DRAINAGE AND TRANSPORTATION INFORMATION SHEET

Re: 6309 Camino Alto NW Residence (SAD 228)
Engineers stamp date 12-22-16 (D10 /D___)

ROYBAL RESIDENCE
6309 CAMINO ALTO N.W.
GRADING & DRAINAGE PLAN

**Re: 6309 Camino Alto NW
S.A.D. 228 Lot 15 Block 2
Grading and Drainage Plan
Engineer's Stamp dated: 12/22/2016 (D10D003C15)**

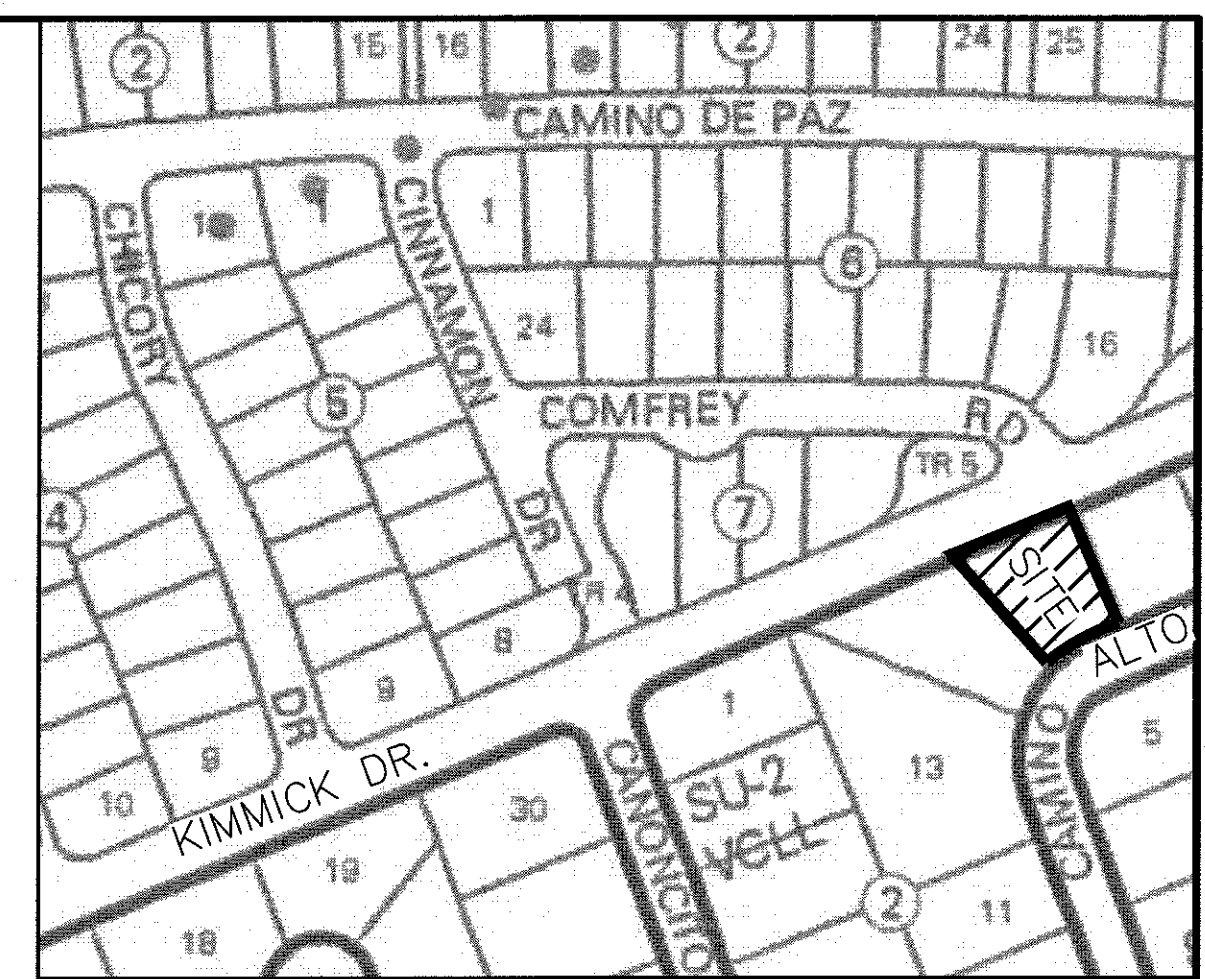
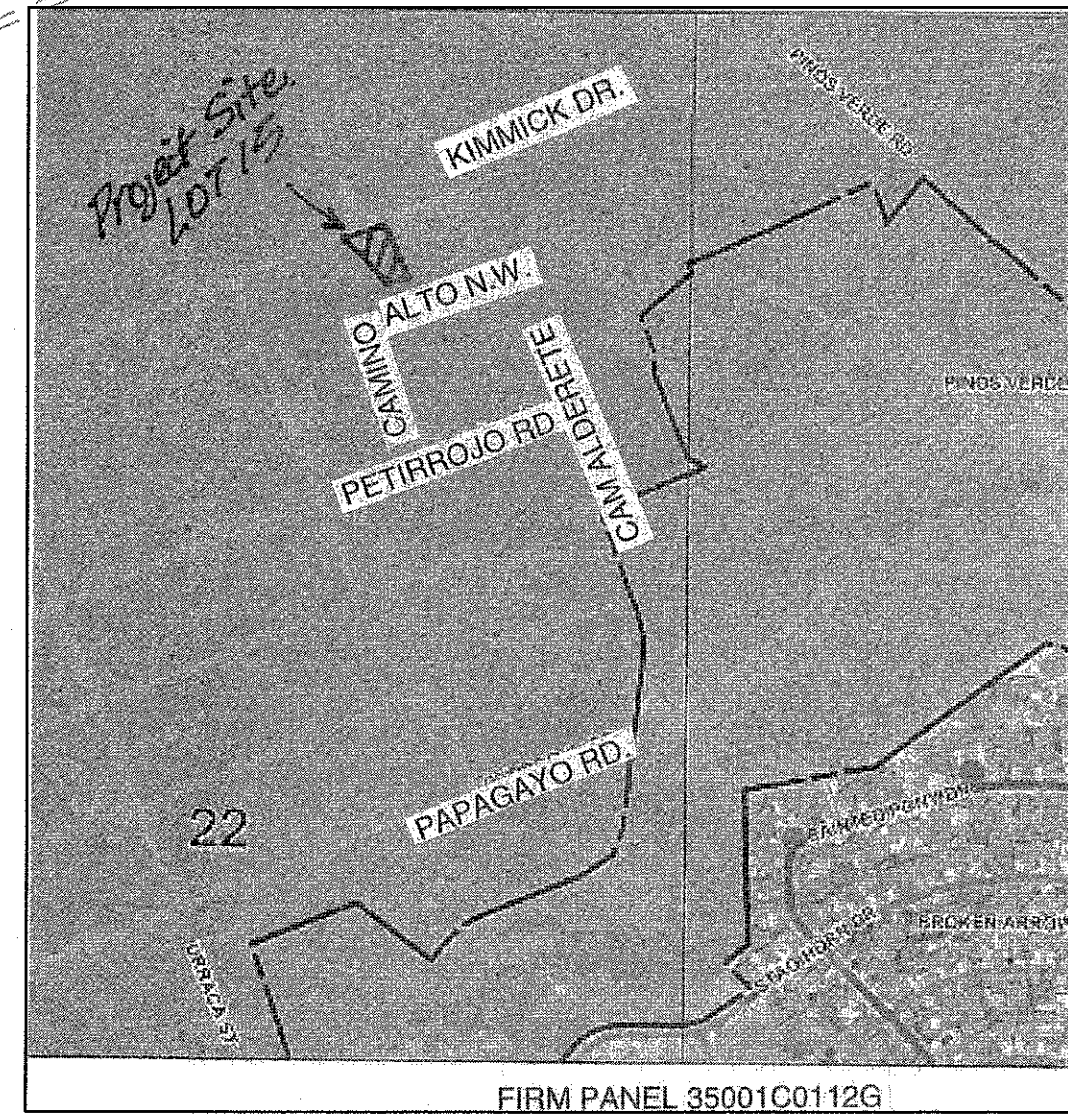
This letter is in response to your informal comment email dated 12-16-16 and our subsequent meeting:

1. The flows from this site have been modified in response to our meeting. Part of the flow is directed to the first flush pond located at the NE corner of the lot with runoff overflow conveyed through two turned blocks at the boundary. A second first flush pond at the SE corner of the property with runoff overflow directed to Camino Alto road.
2. Opening size has been provided on the plan.
3. The spillway elevation from the pond is set at 0.2' higher than the adjacent property as shown on the plan.
4. The note has been added to the construction notes.
5. This has been provided on the plan.
6. This note has been provided in the construction notes on the plan.

Based on the information provided in your submittal received 12/22/2016 the above referenced Grading and Drainage Plan is approved for Grading Permit. The building permit will be approved once a pad certification is completed. Spot elevations are not required, a note on the plans stating that you have visited the site and that the pad is certified by you, which is in compliance with the original G&D plan dated 12/22/16.
